RE: 2019 Inspection of York Haven Fish Passage Facilities

Subject: Fishway Inspection at the York Haven Hydroelectric Project (FERC #1888) on May 21, 2019

Figure 2 – Energy dissipation pool downstream control weir is submerged by tailrace pool

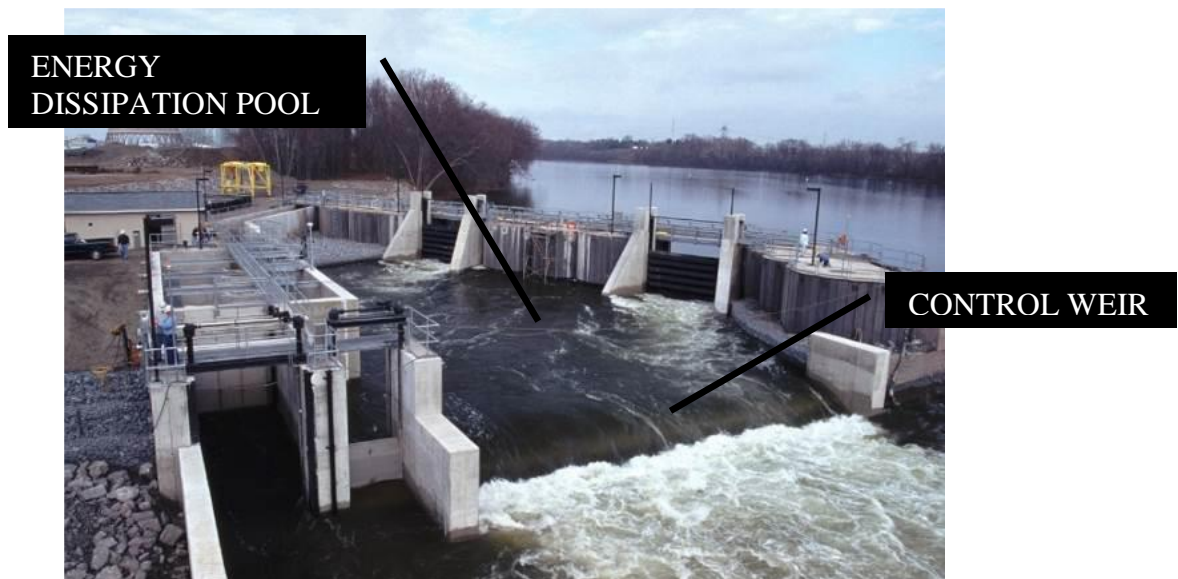
- The energy dissipation pool is accessible for upstream migrants - The hydraulic control weir at the downstream boundary of the energy dissipation pool (Figure 2) is frequently submerged by the water surface elevation of the tailrace. This submerged condition produces a control weir that is technically passable to some target species, making the energy dissipation pool accessible for potential upstream migrants. Once inside the energy dissipation pool, these migrants do not have a safe or effective way to continue their upstream migration. No corrective action is recommended at this time to address this particular issue.

2. Downstream Control Weir and Access to the Energy Dissipation Pool - This possible issue is noted in this report, but the Service is not recommending corrective action at this time.
